Swan and Canning Rivers Management Act 2006

DETERMINATION OF DEVELOPMENT APPLICATION

FILE NUMBER : SRT6018
APPLICANT : City of Belmont
APPLICANT'S ADDRESS : Locked Bag 379
CLOVERDALE WA 6985
LANDOWNER : City of Belmont and Western Australian Planning
Commission
LAND DESCRIPTION : Ayres Bushland, Lots 277, 278 and 279 on Plan 2252
Boulder Avenue, Ascot; and Lot 302 on Plan 47452
(Crown Reserve 48325)
DEVELOPMENT : Demolition of existing boardwalk and construction of a
new boardwalk
VALID FORM 1 RECEIVED : 4 September 2014
DETERMINATION : **APPROVAL WITH CONDITIONS**

PROPOSAL : Demolition of existing boardwalk and construction of a new boardwalk

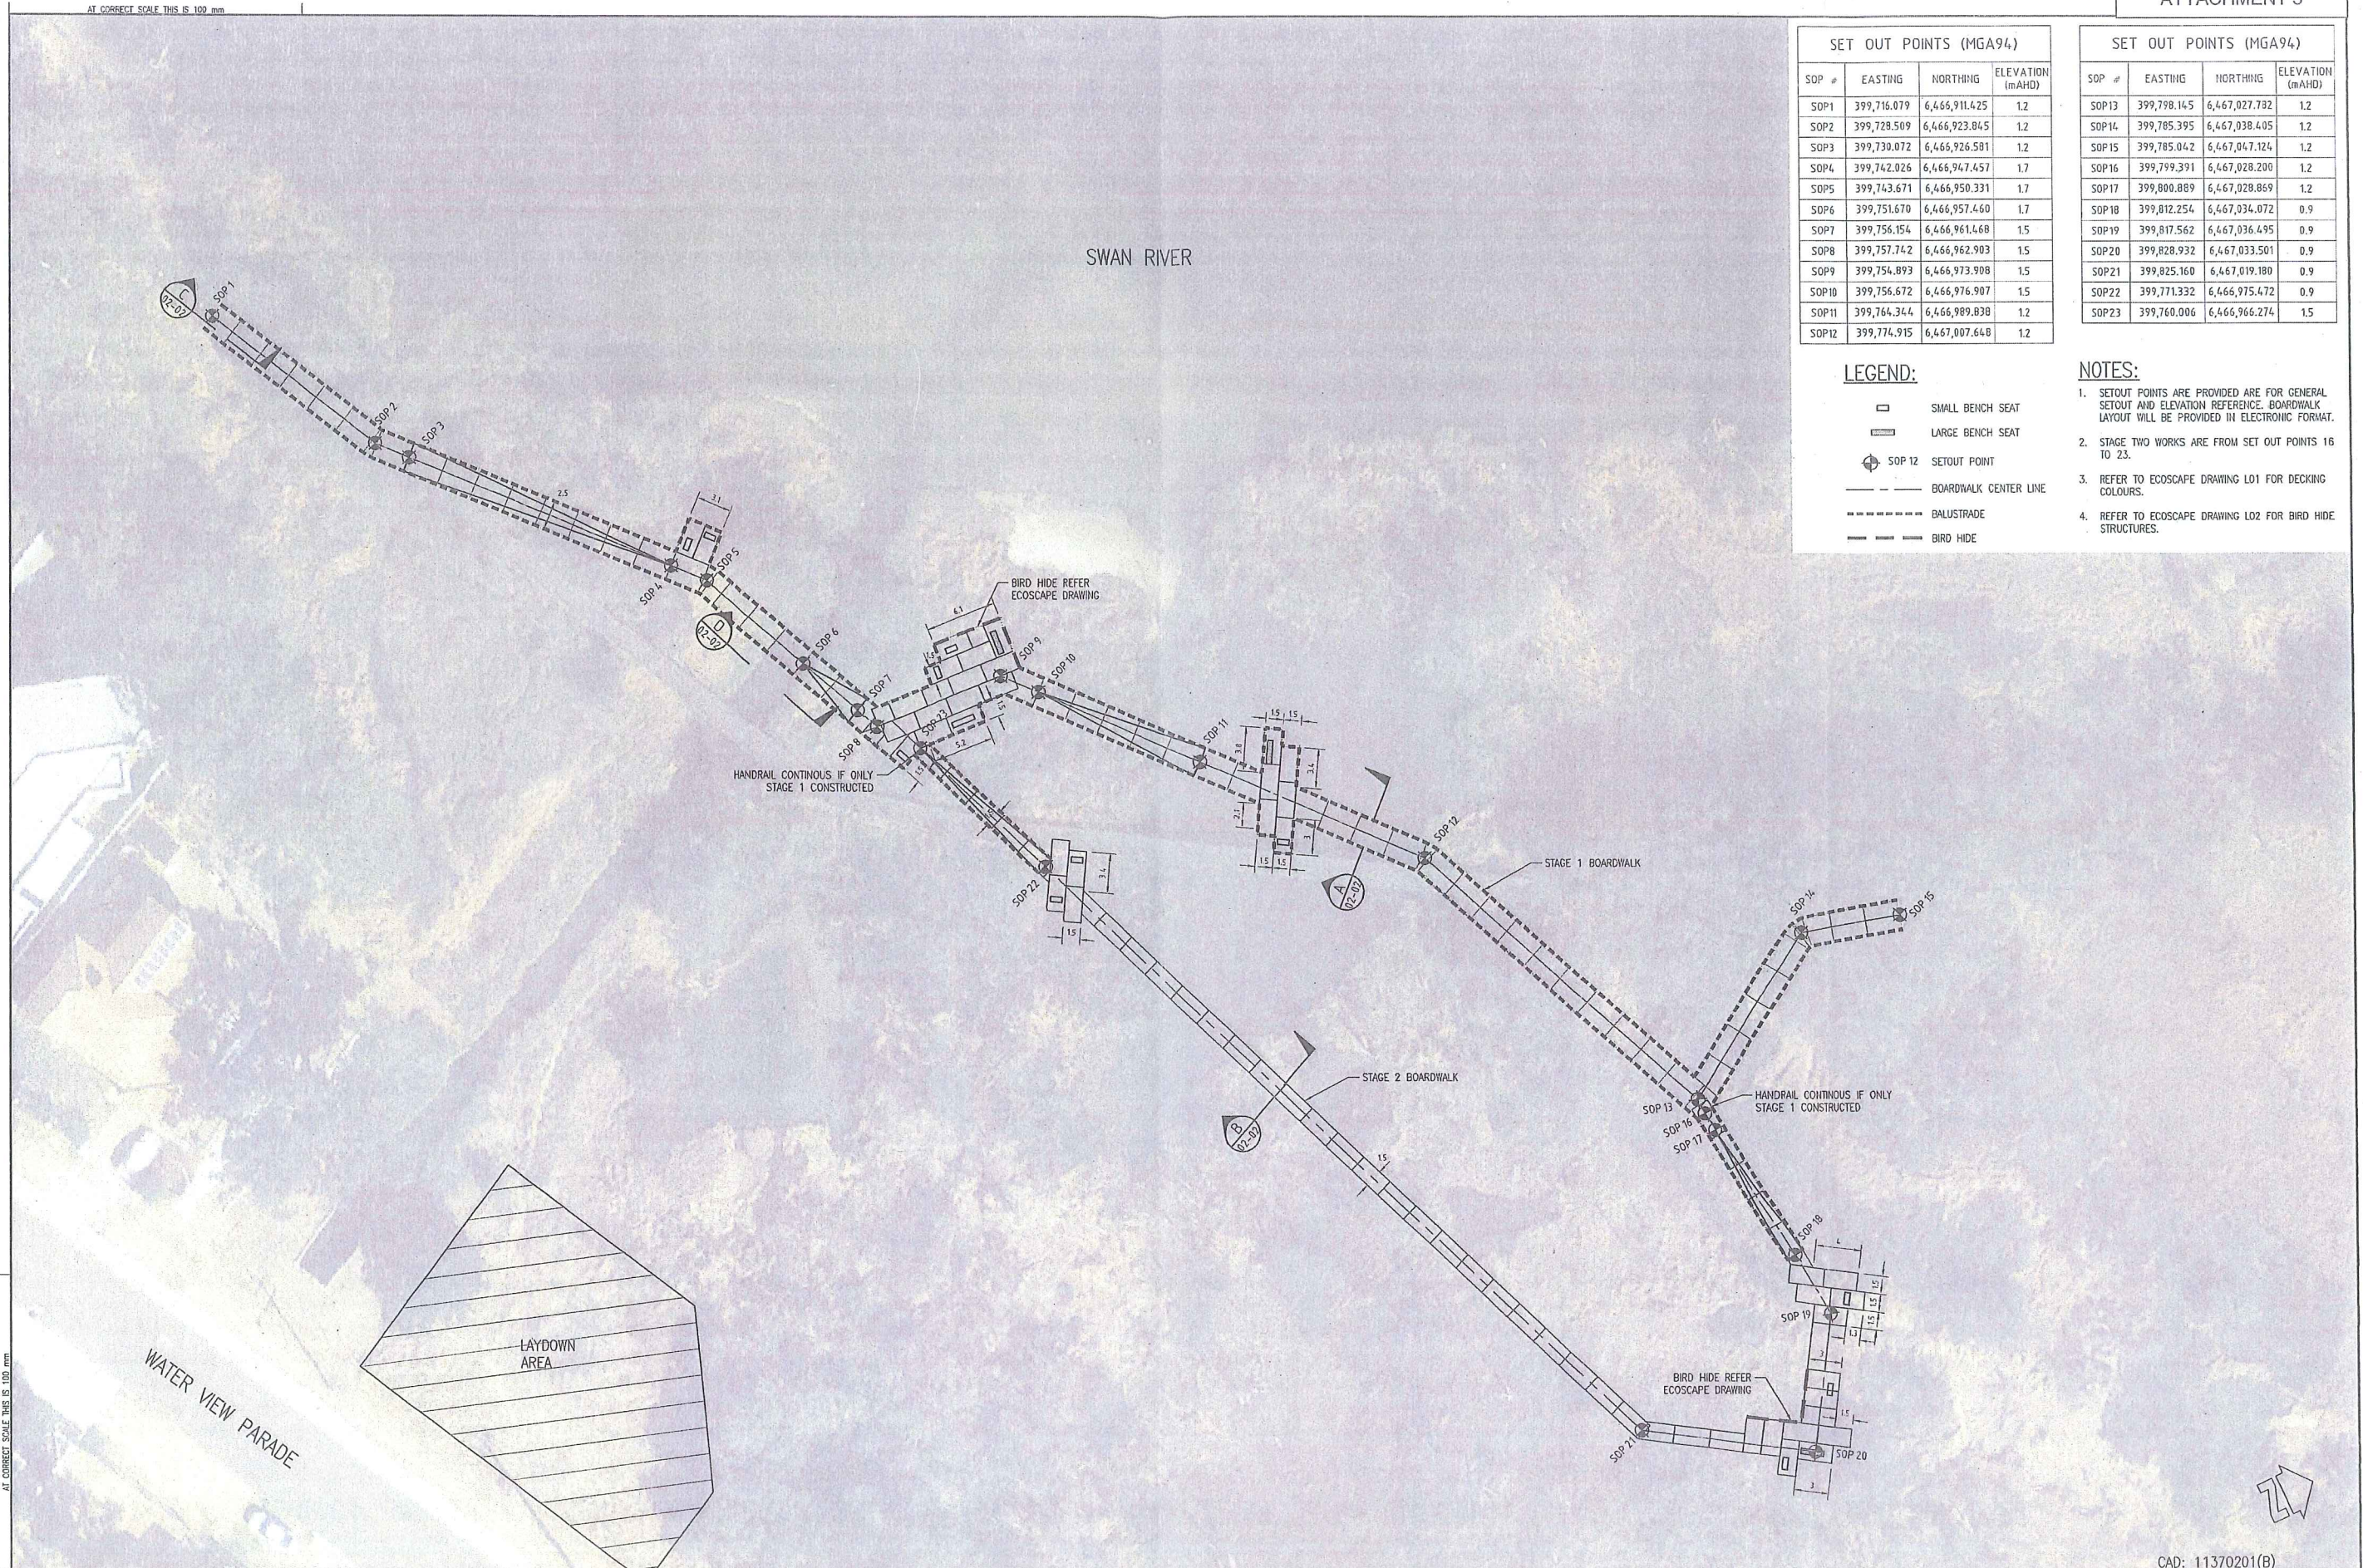
- 6.6 The proposed boardwalk is split into two separate stages. Stage 1 consists of the main boardwalk and Stage 2 consists of a lower boardwalk loop (**Attachment 5**). Depending on the City of Belmont's budget, either both stages will be constructed or just Stage 1. The development application seeks approval of both Stage 1 and Stage 2.

- 7.5 The design of the proposed boardwalk can be seen in **Attachments 5 & 6**. The proposal consists of a wider main boardwalk that is to be constructed at the same height as the existing boardwalk and includes balustrading. This boardwalk will connect the existing shared use paths on either side.

- 7.9 The application includes two bird hide structures (**Attachments 5 & 9**). These bird hide structures are to be constructed as screens from the same FRP grating mini mesh as the proposed decking. The screens will be open structures, constructed on only one side of the boardwalk to ensure public surveillance and reduce anti-social behaviour.

ATTACHMENT 9

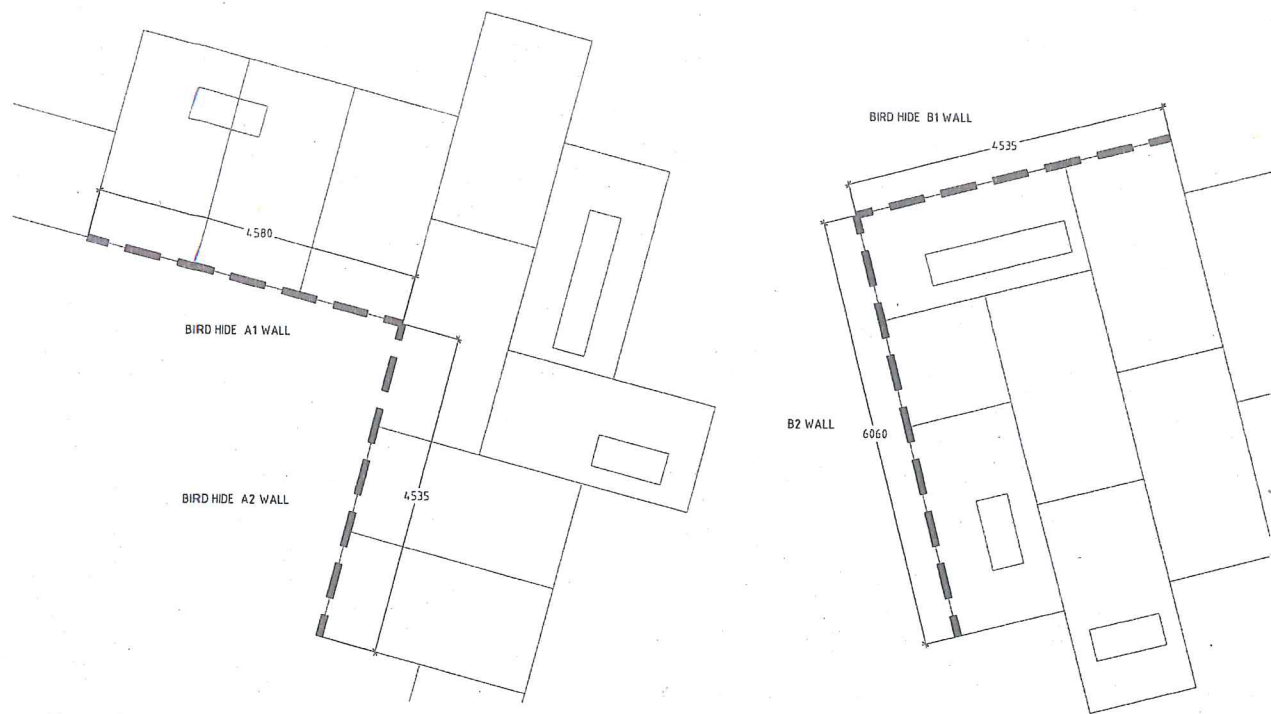
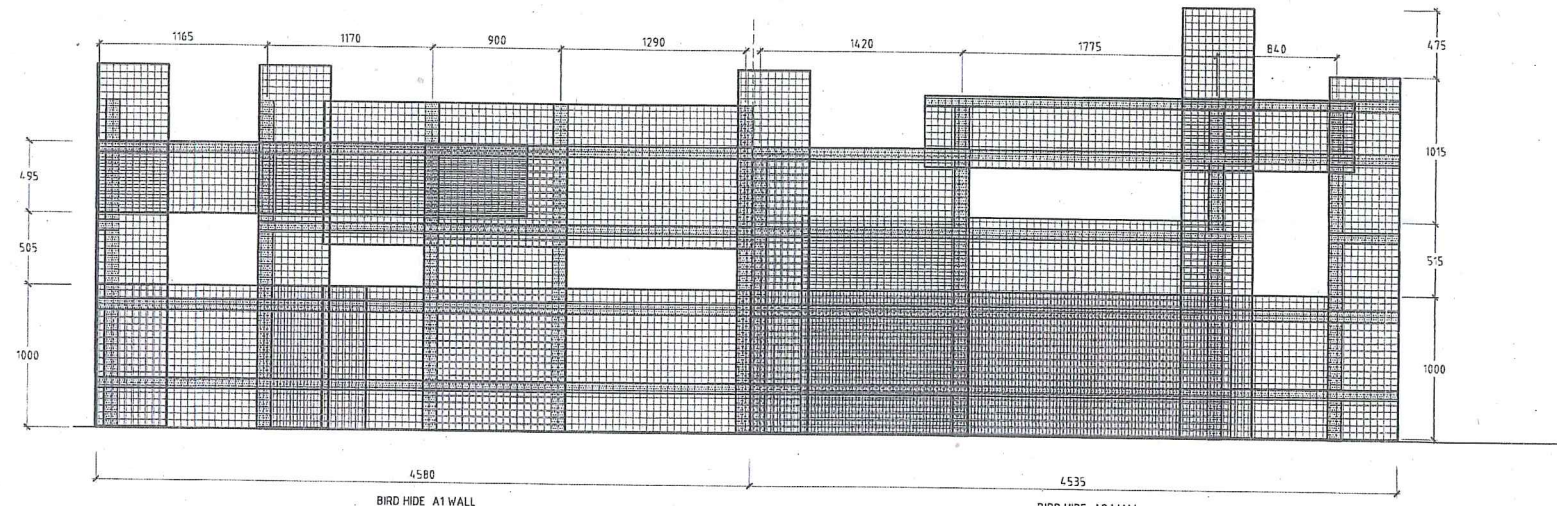
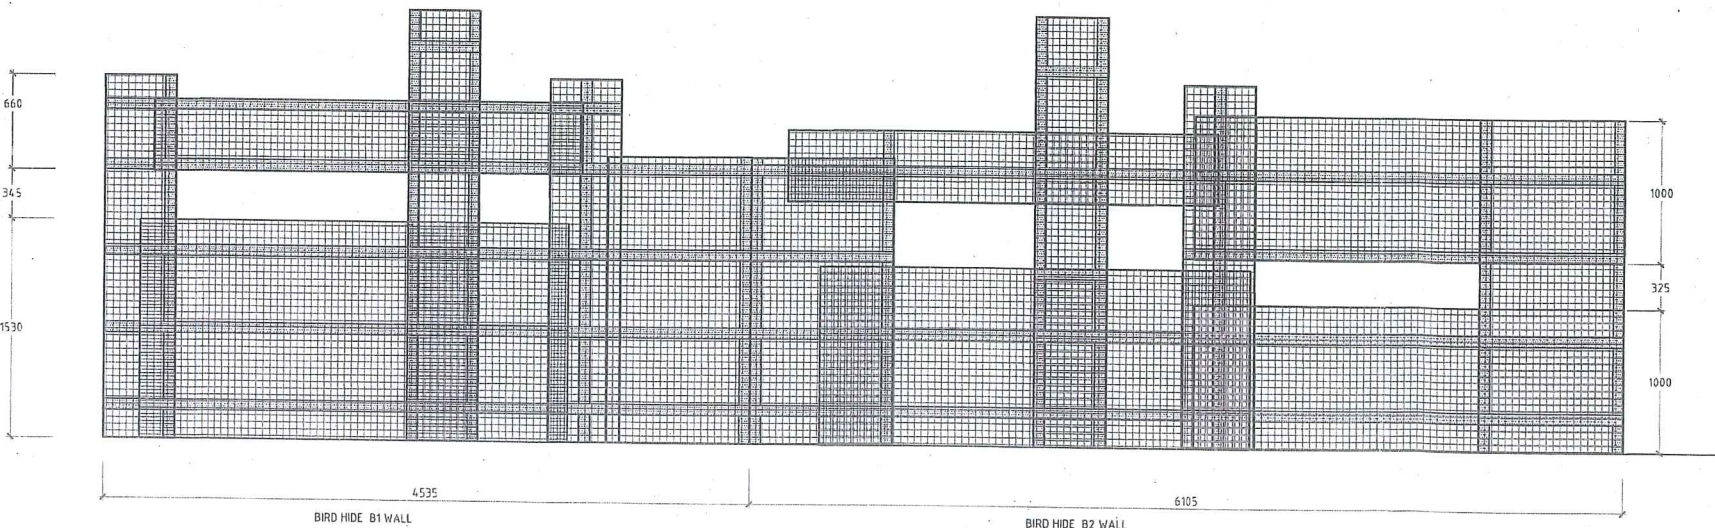
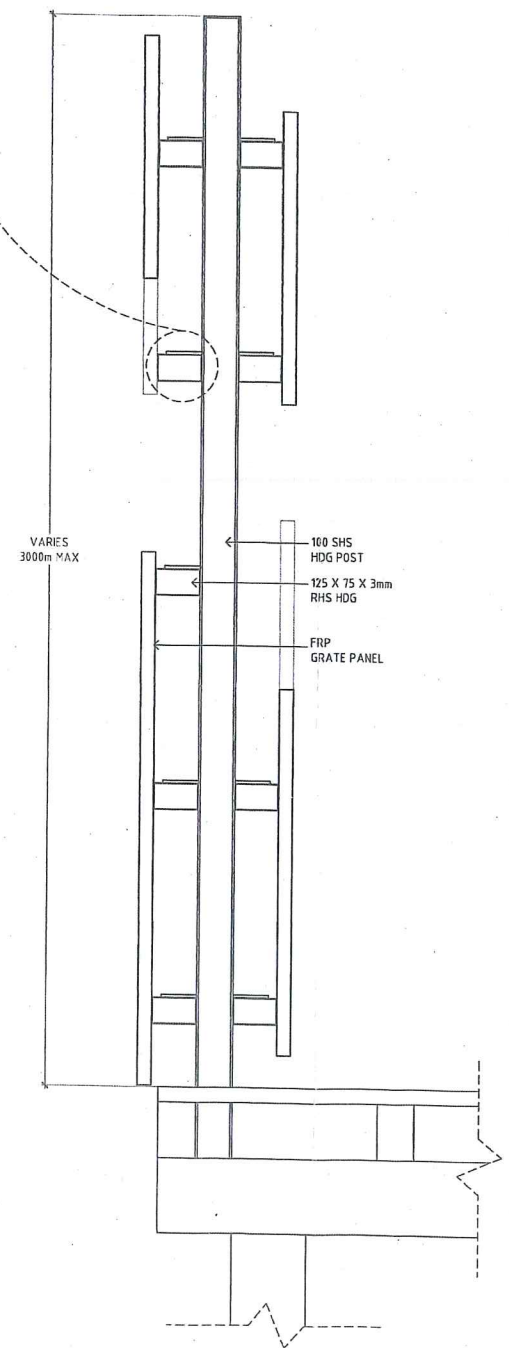
- Colour 1 – RAL 7001 Silver Grey
- Colour 2 – RAL 7011 Iron Grey
- Colour 3 – RAL 5008 Grey Blue
- 7.21 The colour of the proposed bird hide screens has not been specified however the applicant has advised that the colours will be muted tones to blend in with the environment and will tie in with the boardwalk decking colours.
